Groundwater Application Review Summary Form

Application # G- 19402

PUBLIC INTEREST REVIEW FOR GROUNDWATER APPLICATIONS

TO: Water Rights Section Date January 12, 2024
 FROM: Groundwater Section Gabriela Ferreira
 Reviewer's Name
 SUBJECT: Application G- 19402 Supersedes review of _____
 Date of Review(s) _____

Well Statistics

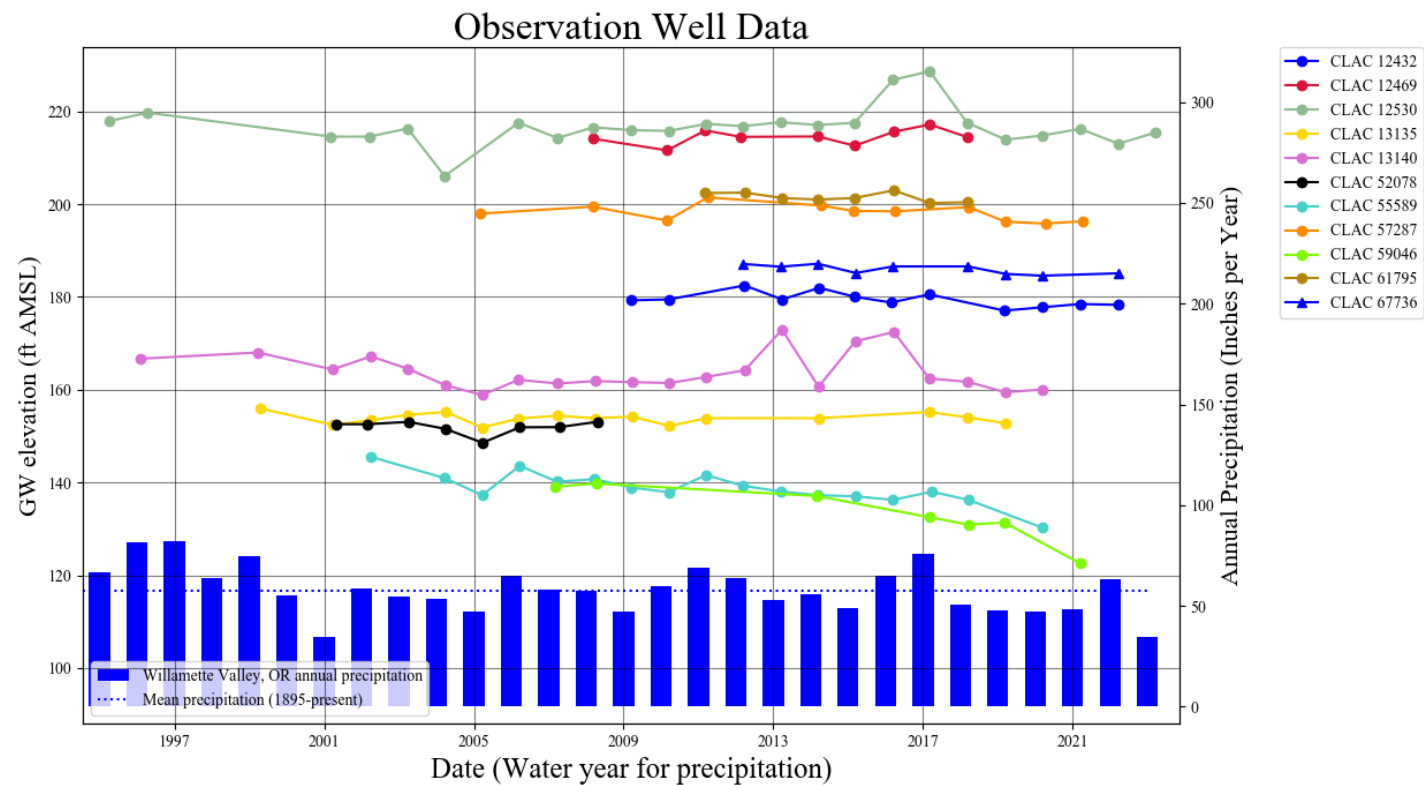
- B3. **Groundwater availability remarks:** The proposed POAs are located in the central Willamette Valley and will produce from water-bearing sand and gravel layers within the Willamette Aquifer and the Willamette Confining Unit. The proposed POAs are located on the northern margin of the the Molalla alluvial fan, approximately 50 ft thick and comprising the Willamette Aquifer. The underlying Willamette Confining Unit is approximately 800 feet thick (Gannett and Caldwell, 1998). Bedrock (Columbia River Basalt Group) is encountered at depths greater than 800 feet. The majority of wells in the immediate vicinity draw water from the Willamette Aquifer or upper Willamette Confining unit (see attached well statistics).

Within approximately one mile of the proposed POA locations, there are about 30 water rights, typically irrigation and nursery use wells completed in the alluvial aquifer system, with several more exempt (domestic) wells also likely in the area. Reported maximum yields in the nearby alluvial wells (mostly domestic) typically range up to 200 gpm, with a few wells reporting 500 – 2500 gpm. Well deepenings are not prevalent. The pump test for proposed POA CLAC 12433 reported a yield of 164 gpm, which is less than half of the proposed maximum rate (430 gpm).

Eleven wells with sufficient water level data for evaluation were identified within approximately 2 miles of the proposed POAs, ranging in total depth from 150 to 300 feet bls. Reported water level elevations for these wells range from about 120 feet above mean sea level (amsl) to 220 feet amsl. Water level data for these wells are generally stable over the time period available (1997 through present) with variability up to 15 feet. Nearly 20 feet of decline is observed in water levels from two well (CLAC 59046 and CLAC 55589) from 2014 – 2021 although the time period coincides with drought conditions and is not long enough to be conclusive.
